REGIONAL REVIEW NOTIFICATION

Name of Proposal: Panattoni Industrial Development

Review Type: Development of Regional Impact

Preliminary Report:	July 13, 2005	DEVELOPMENT OF REGIONAL IMPACT REVIEW REPORT	Project:	Panattoni Industrial Park # 798
Final Report Due:	Aug 12, 2005		Comments Due By:	July 27, 2005

THIS PLAN IS A CONCEPTUAL REPRESENTATION
OF THE PROPOSED SITE DEVELOPMENT.
FINAL LAYOUT CONTINGENT UPON BOUNDARY
/ TOPO SURVEY and JURISDICTIONAL PERMITTING.

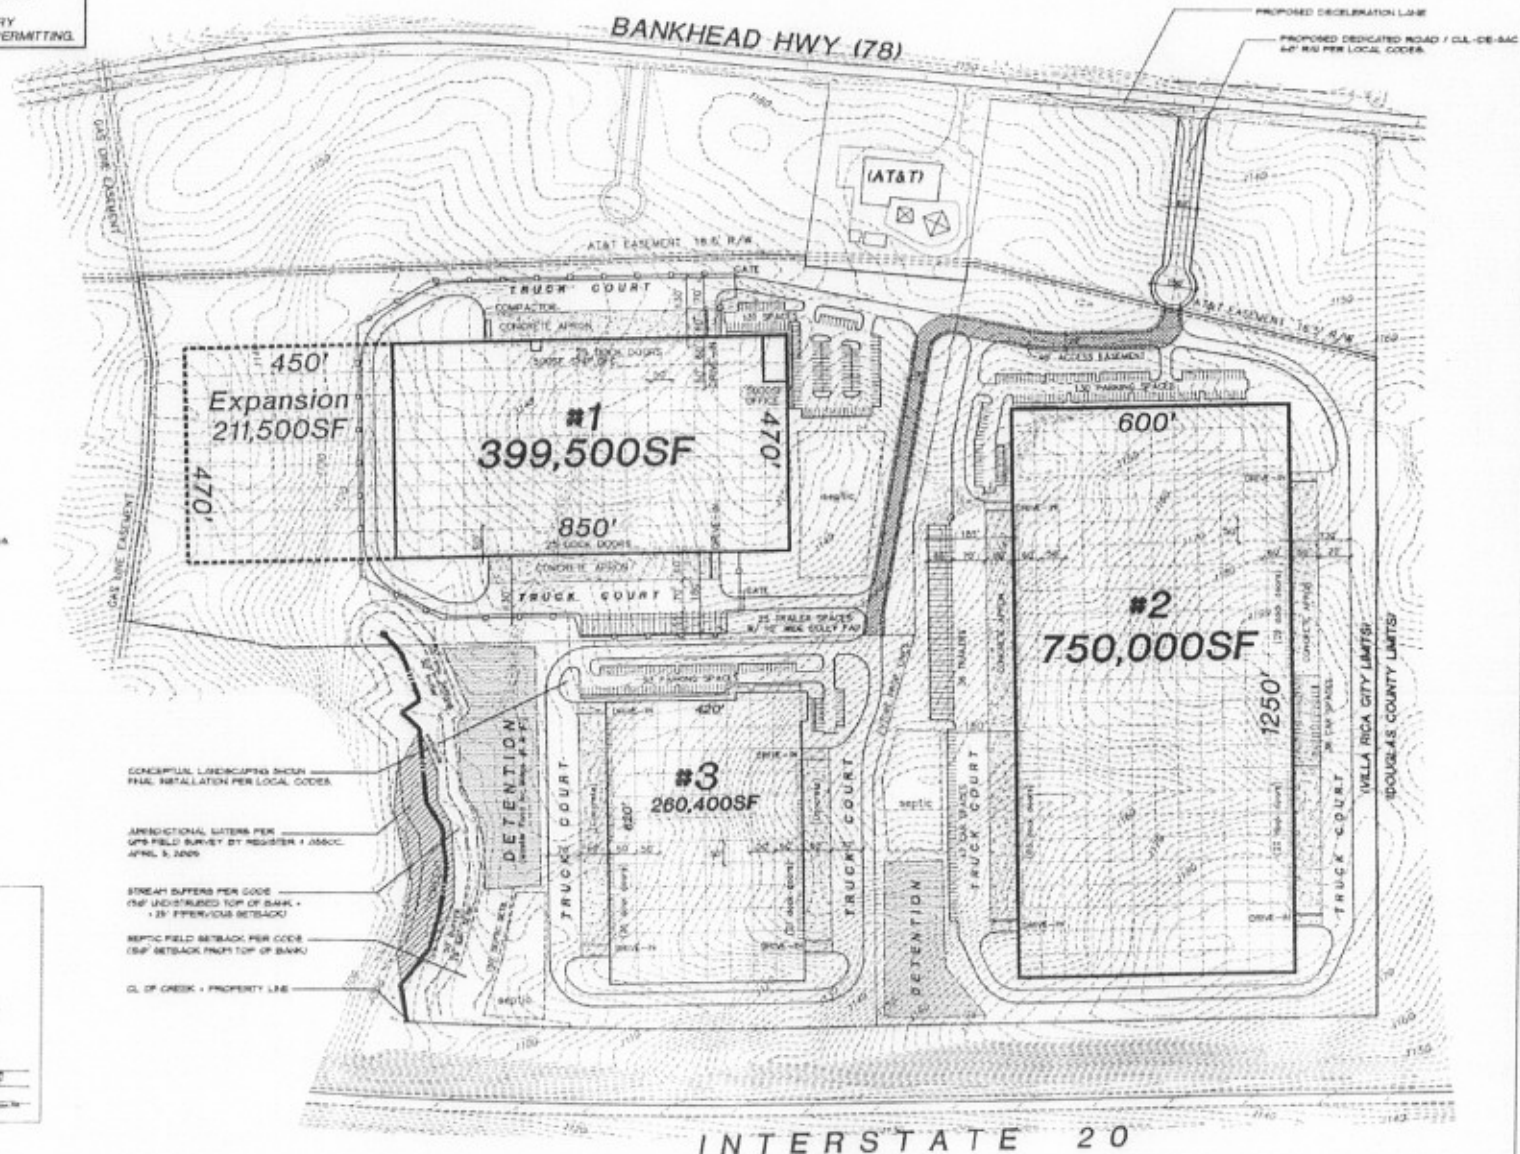
The Watershed Protection District has a limit of 25 percent impervious surface area for the entire water supply watershed area in the City. Site plan information provided on the submitted concept plan shows an estimated footprint coverage of 42.3 percent and an additional impervious cover area (assumed to be drives, parking and loading areas) of 22.4 percent, for a total of 64.7 percent impervious. To meet the Watershed District requirements, the project needs to meet the impervious surface limits on site or the City of Villa Rica must show how the proposed impervious area over 25 percent is permanently offset elsewhere in the City's portion of the watershed.

Refinement of the site plan is recommended to maintain and improve the environmental integrity of the surrounding area. Clear cutting of the vegetation should be minimized where possible. It is recommended that appropriate measures are taken to ensure the protection of the stream on the western portion site.

The proposed industrial park is located entirely within the Dog River Water Supply watershed, a small (less than 100-square mile) public water supply watershed serving Douglas County. All development on the property must conform to the City of Villa Rica City Code Water Supply Watershed District Requirements, which include the Dog River watershed and is consistent with the Part 5 minimum water supply watershed criteria adopted by Georgia DCA and EPD, including buffers, water quality controls and impervious surface limits. The Villa Rica Watershed Protection District requires a 100-foot vegetative buffer and 150-foot impervious surface setback on all perennial streams within seven miles upstream of a public water supply intake or reservoir and a 50-foot vegetative buffer and 75-foot impervious surface setback on all perennial streams more than seven miles upstream of a public water supply intake or reservoir. This project is more than seven miles upstream of the Dog River Reservoir. Although no perennial streams are shown on the USGS 1:24,000 coverage for the project area, an intermittent stream is shown. The proposed site plan shows a 50-foot vegetative buffer and 75-foot impervious setback on a portion of the intermittent stream on the property.

The Watershed Protection District also has a limit of 25 percent impervious surface area for the entire water supply watershed area in the City. Site plan information provided on the submitted concept plan shows an estimated footprint coverage of 42.3 percent and an additional impervious cover area (assumed to be drives, parking and loading areas) of 22.4 percent, for a total of 64.7 percent impervious. To meet the Watershed District requirements, the project needs to meet the impervious surface limits on site or show how the proposed impervious area over 25 percent is permanently offset elsewhere in the City of Villa Rica's portion of the watershed.

A portion of the intermittent stream shown on the USGS coverage for the site appears to be covered with buildings and impervious surface in this project design. All streams and any other waters of the State on the property must conform to the State 25-foot erosion and sedimentation buffer. Any work proposed within that buffer must conform to State erosion and sedimentation requirements and must be approved by the appropriate agency.

ARC staff would like to discuss with the City of Villa Rica and the developer the above issue of impervious cover area. ARC recently adopted a policy regarding impervious surface limits in small water supply watersheds. The policy resolution is attached at the end of this report. ARC's review will use this policy to evaluate the proposed development and the City's implementation of protection measures of the watershed.
